**DATE:** July 15, 2009

## Addenda No. 1

**SUBJECT:** Mill Creek (Cottage St) Bridge (Salem) Section  
Cottage Street NE  
Marion County  
Grading, Sidewalks, & Landscaping Project  
(Bids to be opened and read July 23, 2009)

SHEET NO.  
GN-2

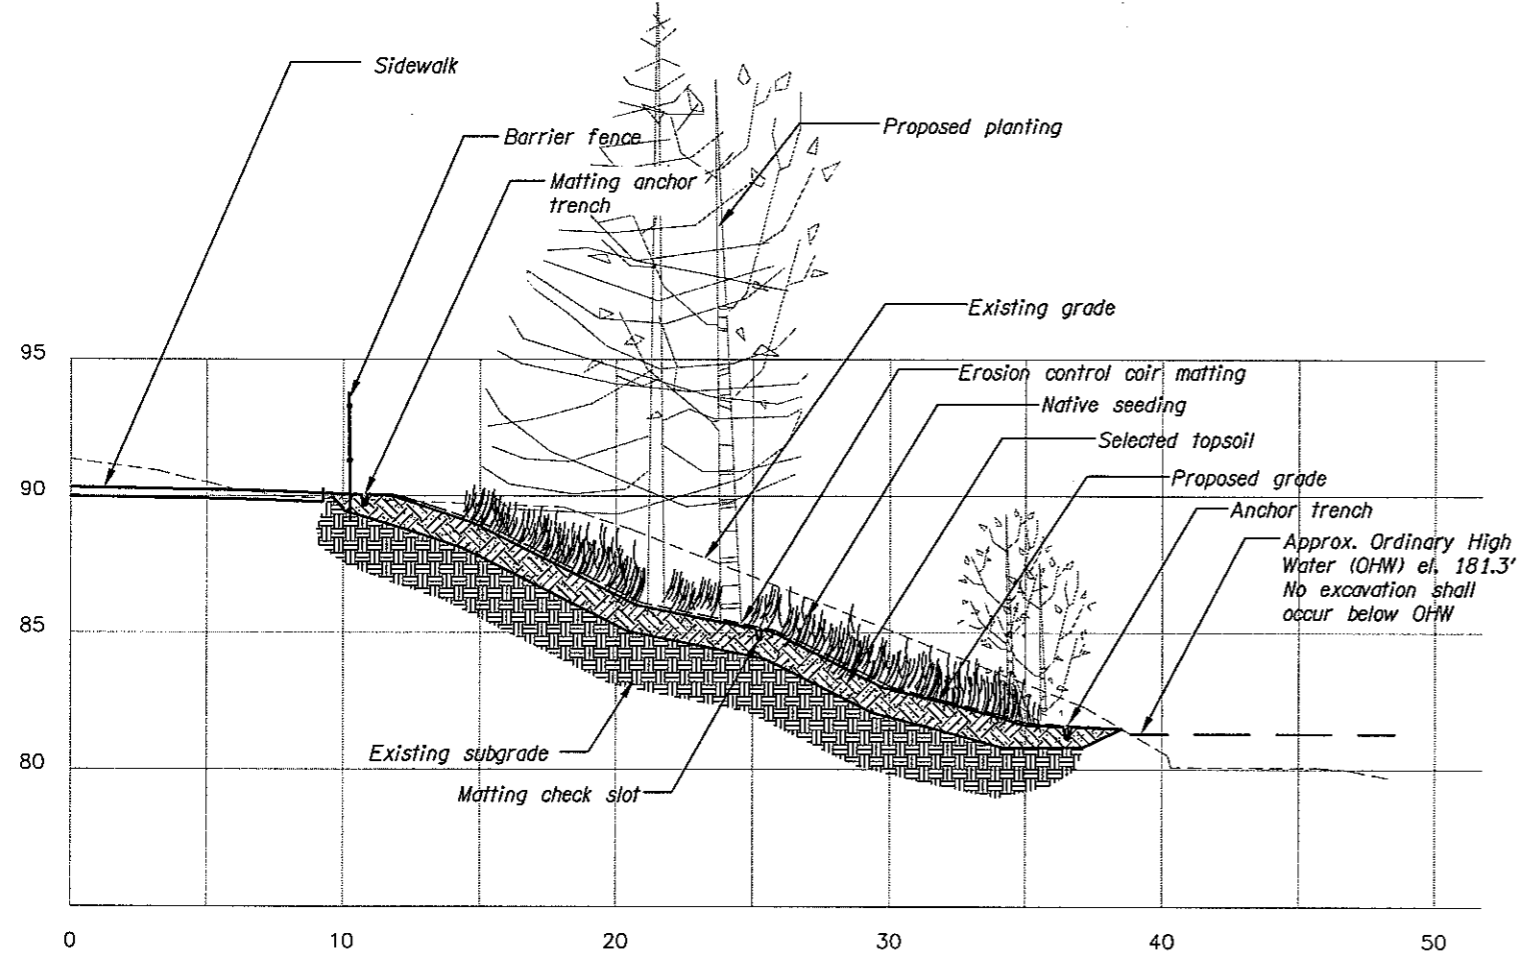
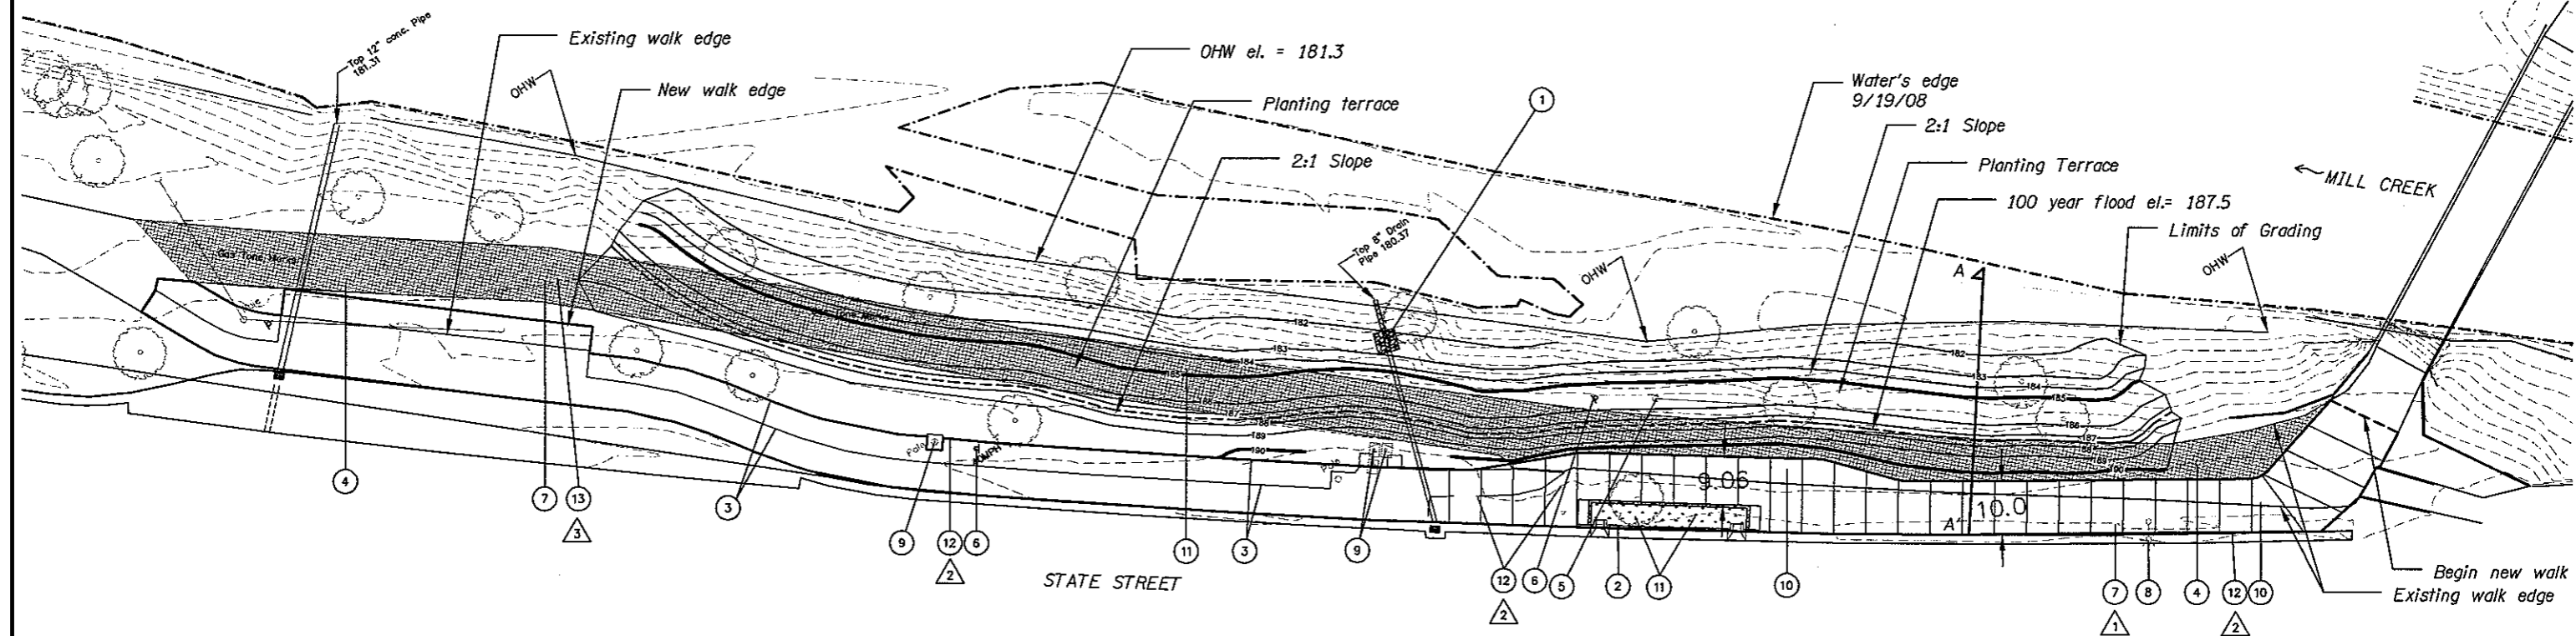
1. Plan sheet GN-2 is replaced with revised plan sheet GN-2.

- ① Const. riprap basin (class 50) 4'x4'x1' (For Details see Sht GJ)
- ② Const. Stormwater Planter, Install 12" thkn. growing medium, 111 CF (4.1 CY) (For Details, see Sht GJ-2 & GJ-3)
- ③ Const. 4' wide conc. sidewalk widening - 3245 SF. For widened sidewalk segment, match existing joint pattern and finish
- ④ Remove existing asphalt walk - 3750 SF
- ⑤ Remove extg. utility pole - 1 (by others)
- ⑥ Relocate extg. sign - 2
- ⑦ Adjust utility junction box to new grade - 2 (by others)
- ⑧ Protect extg. luminaire
- ⑨ Protect extg. traffic signal poles and cabinets
- ⑩ Const. conc. multi-use path - 2565 sf Const. score joints 6' O.C. as shown See Std. Dwg. No. RD720 Sidewalks)
- ⑪ Locate and protect extg. utilities
- △② Adjust junction box to new grade - 4
- △③ Protect extg. gas line

REVISIONS	
△1	Revised 7-16-09 Revised Quantity
△2	Revised 7-16-09 Added Note
△3	Revised 7-16-09 Added Note
